TENANT IMPROVEMENT WORK FOR

intimissimi

SPACE #111
WESTFIELD GALLERIA AT ROSEVILLE
1151 GALLERIA BLVD,
ROSEVILLE, CA 95678

12.13.2024	LL PERMIT SET	
	DATE	REVISION

1 | STOREFRONT ELEVATION |
A301 | SCALE 3/8"=1' |

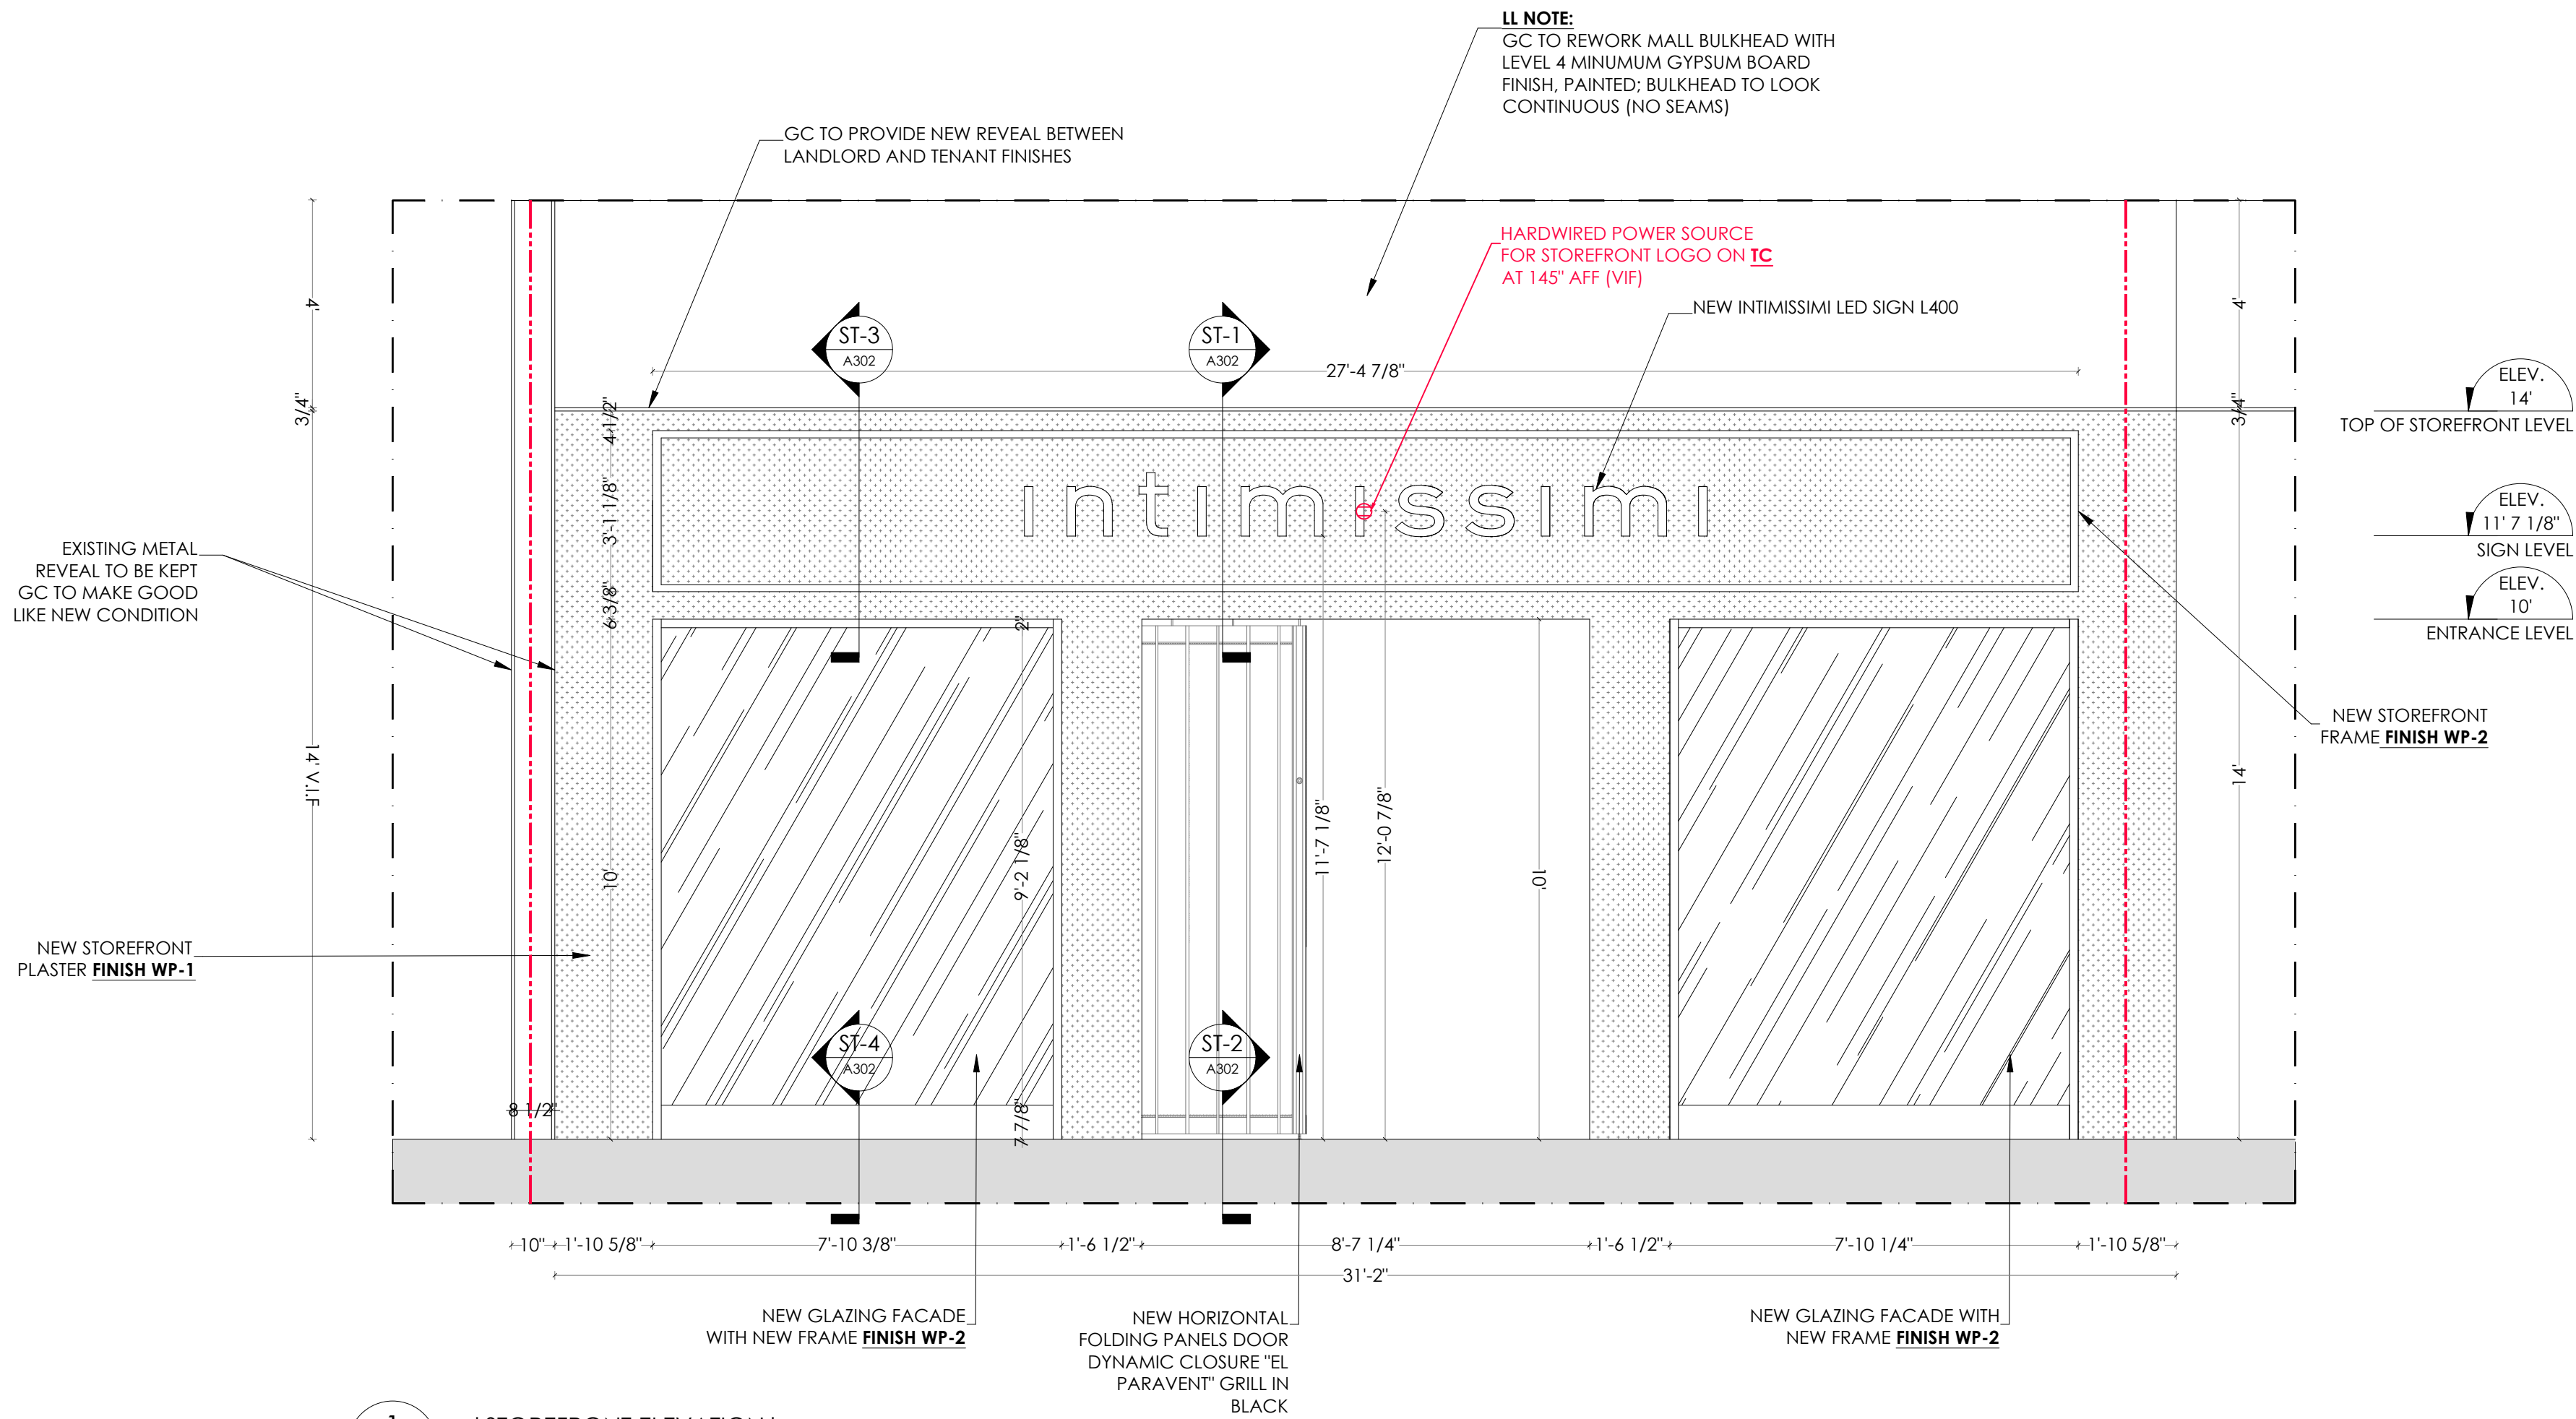
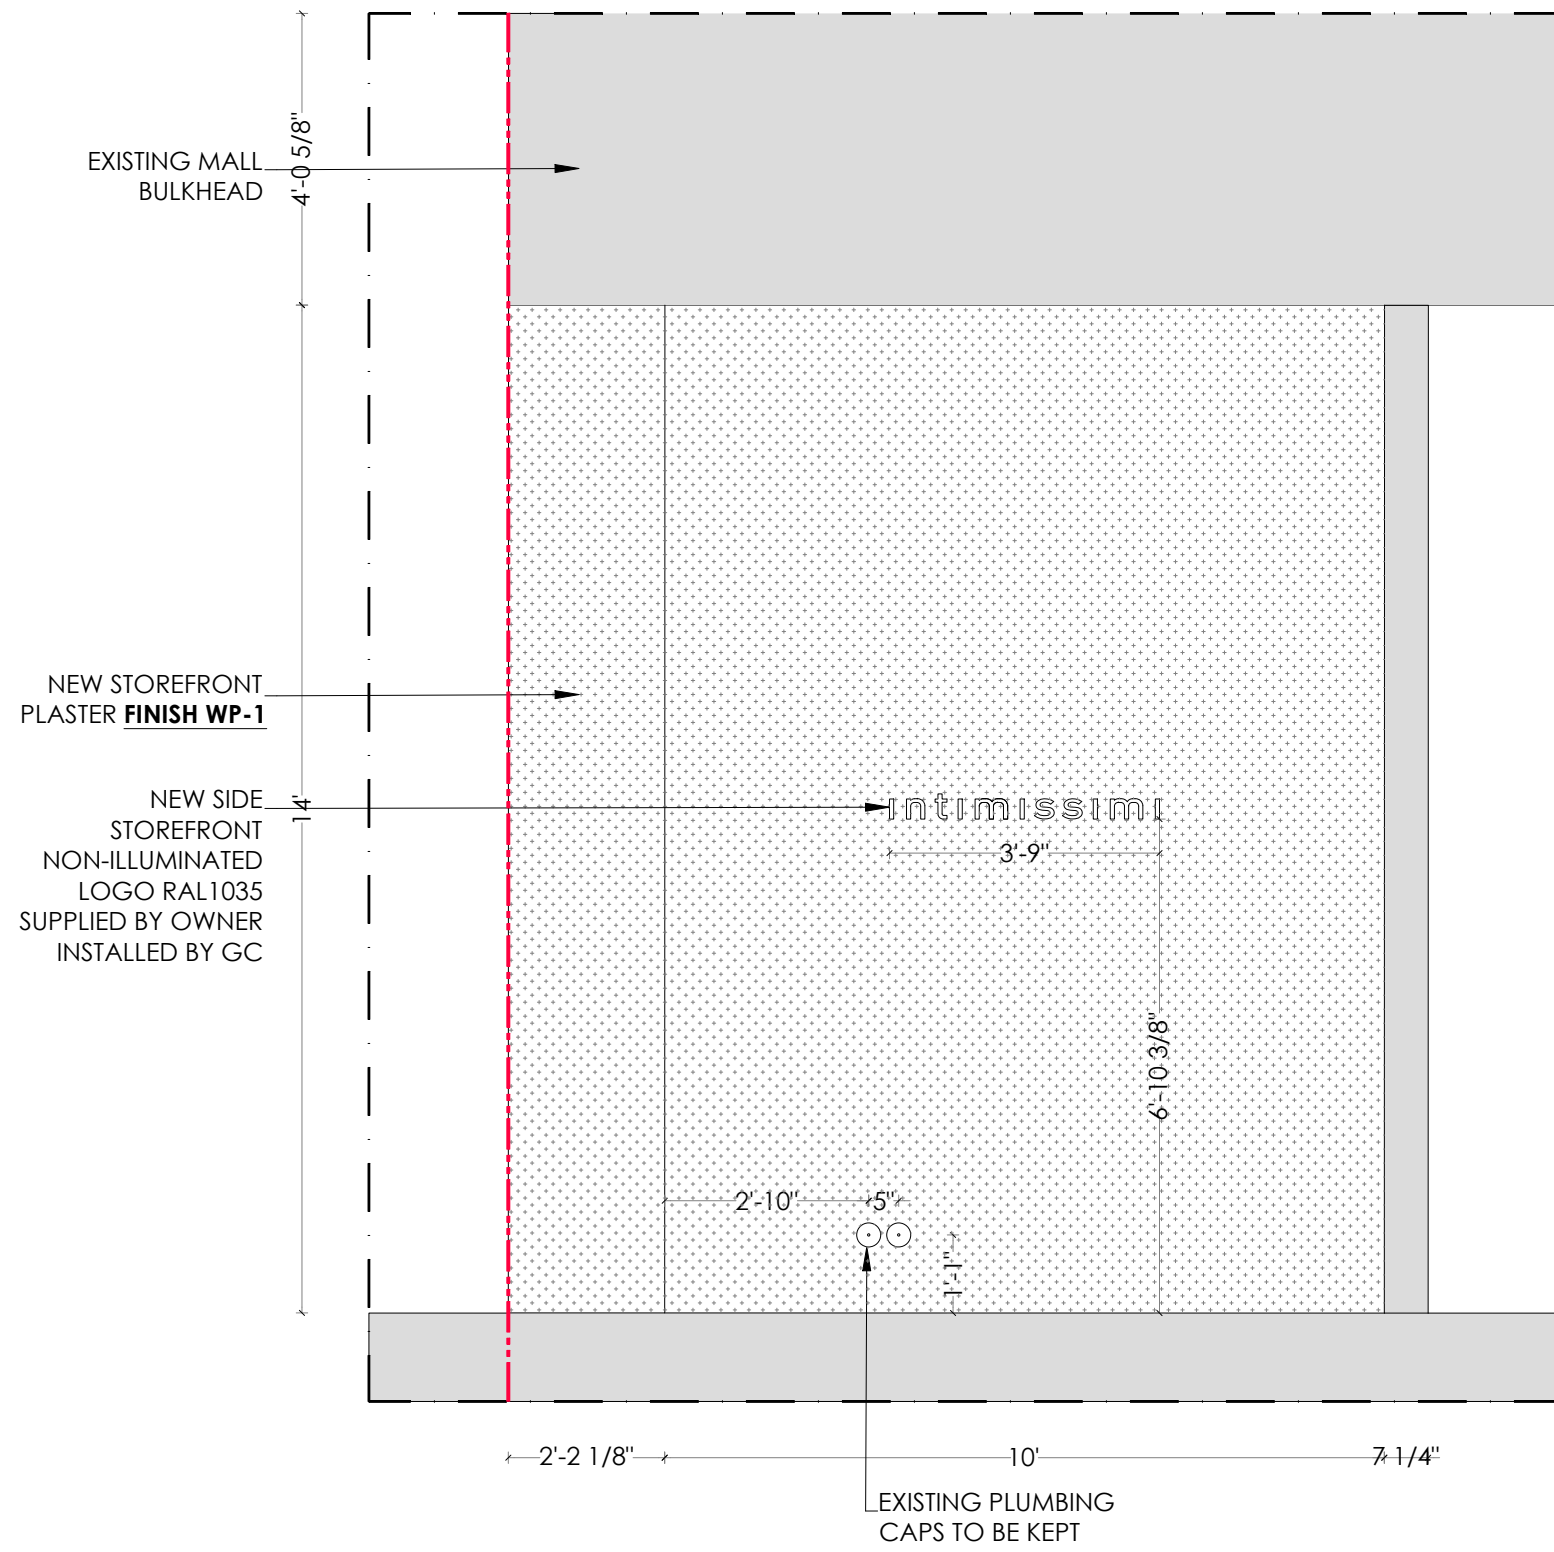
LANDLORD REVIEW COMMENTS
